ADDENDUM NO. 3

Project Name: Moorhen Marsh Low Energy Aquatic Plant System

Bid Number: 2020030

Revised Sheet E5 – Electrical Equipment Schedules and Details

LIGHTING POLE WITHOUT GROUND ROD DETAIL (TYPICAL)
SCALE: NONE

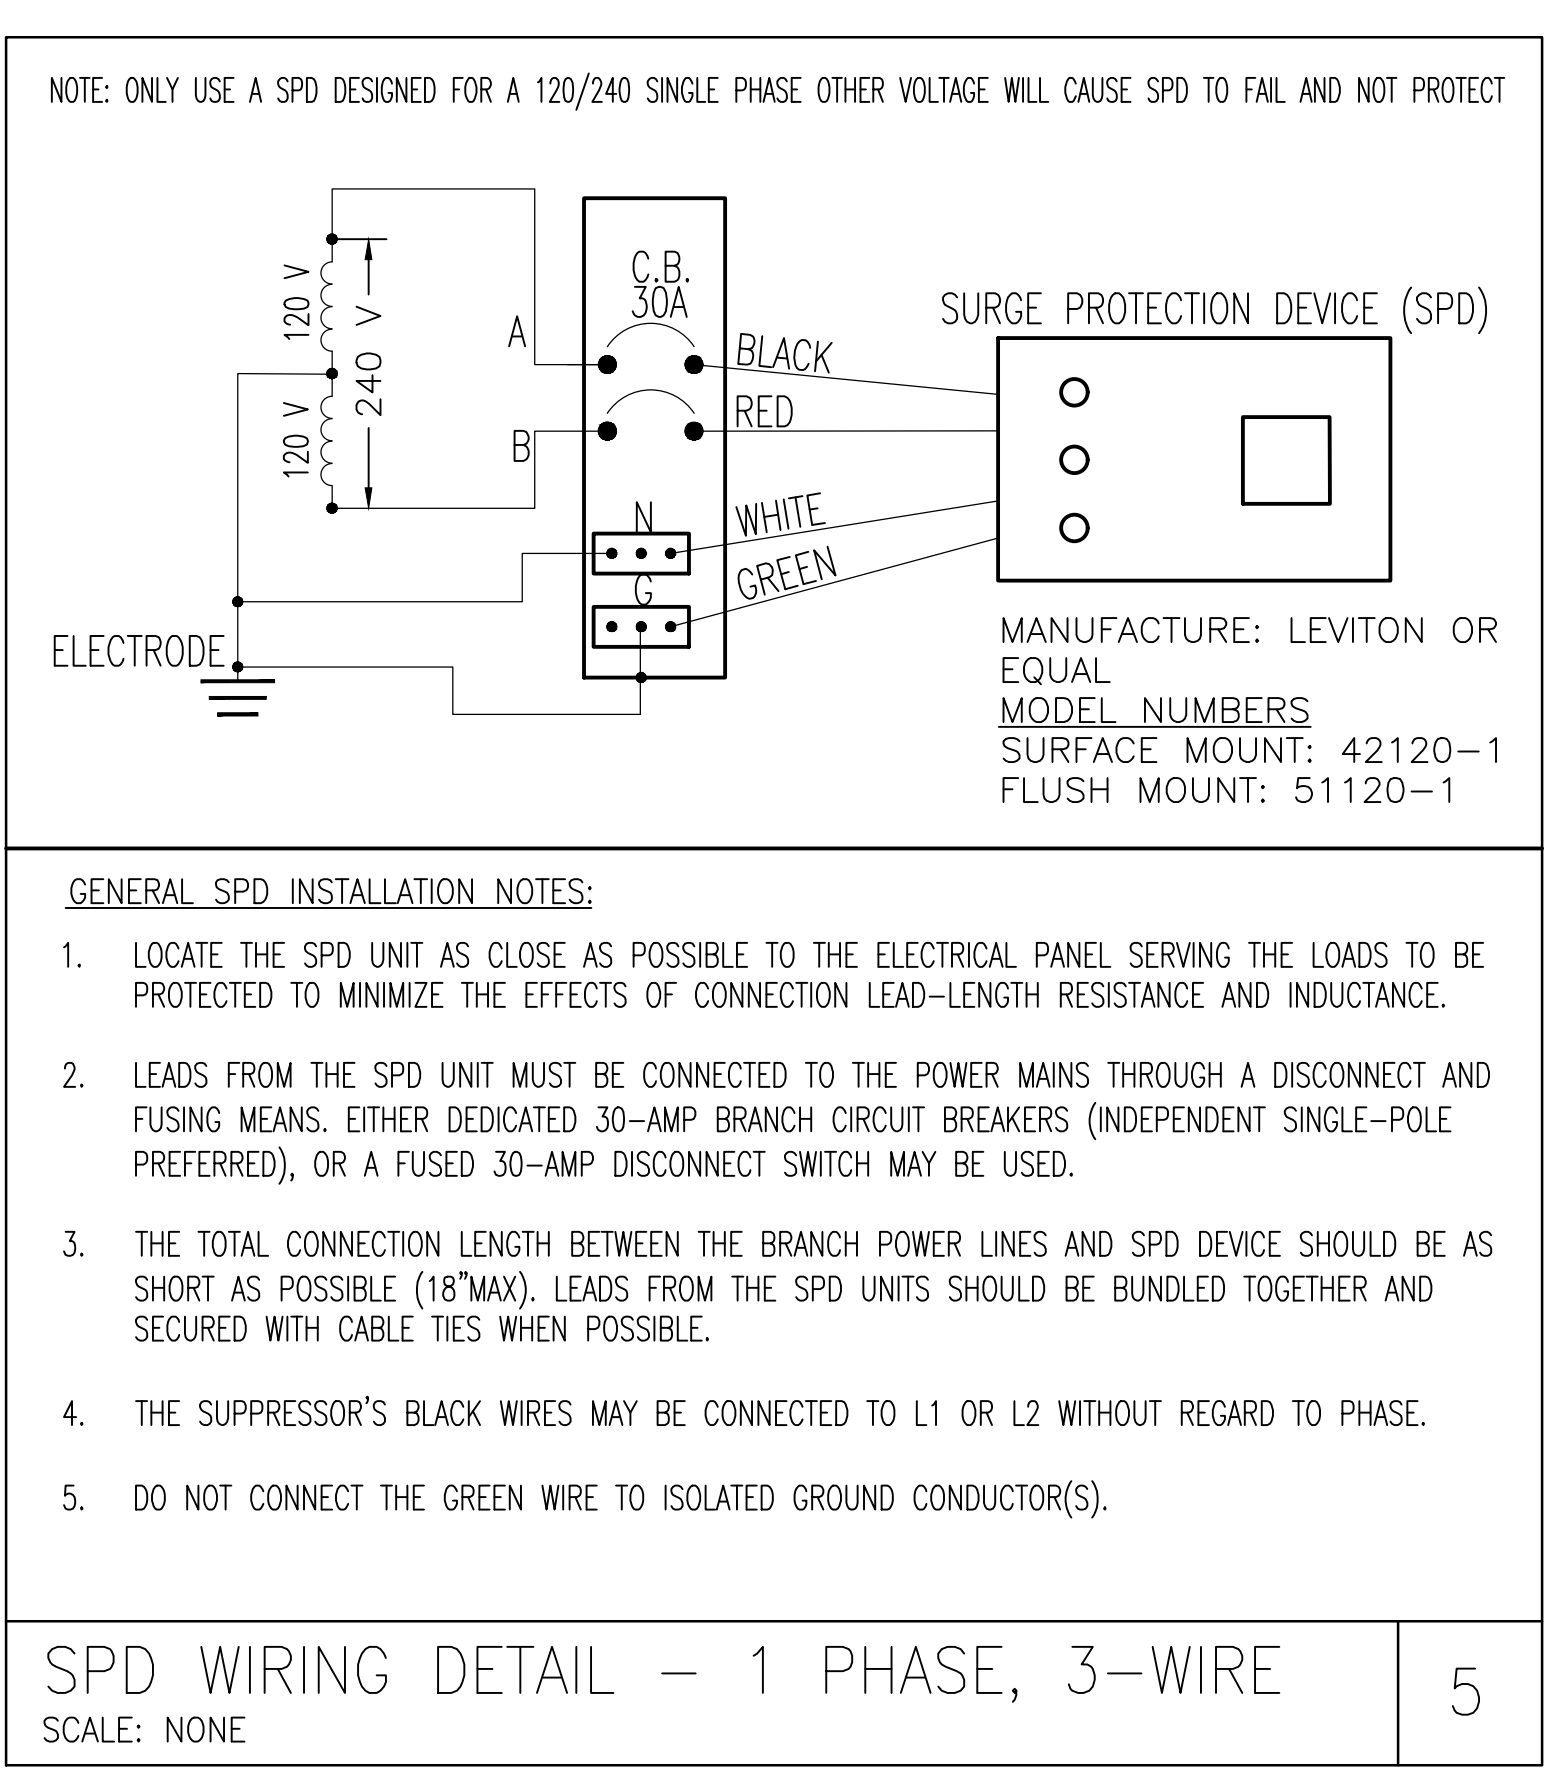
1. Question regarding Luminaire Schedule on E5 Top right of the page gives pole description as direct burial concrete. The part number in the luminaire schedule is for an aluminum pole. Please advise.

Response: The pole shall be concrete. The note in the Luminaire Schedule on Sheet E5 (attached) has been revised to state: "MOUNTED ON UTILITIES STRUCTURES INC. POLE # US117TI-6636. 12 FT ABOVE & 5 FT BELOW."
2. Section 02235. In the landscape specs 3.25 & 3.26, the notes in the drawing L2 regarding the "PURPLE" color code planting for Wetland Polishing Marsh, it mentions using 2" plugs for the aquatic plant, duck potato. When other aquatic plants (pickerelweed, bulrush & club rush) in 3.22 & 3.23 were specified as being bare root. Can we use the bare root for the duck potato also.

CALLOUT	SYMBOL	LAMP	DESCRIPTION	MOUNTING	MODEL	INPUT WATTS	VOLTS	NOTE 1
A		(1) 77W LED	LOW BAY PENDENT-TOP BAY LED	JBOX/HOOK /PIPE MOUNT	METALUX TBLED-LD1-8-W-UNV-L840-CD1-U	77	120V 1P 2W	
B		(1) 58W LED	WALL MOUNT LED LUMINAIRE W/PHOTOCCELL	WALL	LUMARK XTOR6B-PC1	58	120V 1P 2W	
S1		(1) 191W LED	LED SITE LUMINAIRE	POLE	MCGRAW EDISON GLEON-AF-03-LED-E1-5MQ-FINISH	191	120V 1P 2W	MOUNTED ON UTILITIES STRUCTURES INC. POLE # US11711-6636. 12 FT ABOVE & 5 FT BELOW.
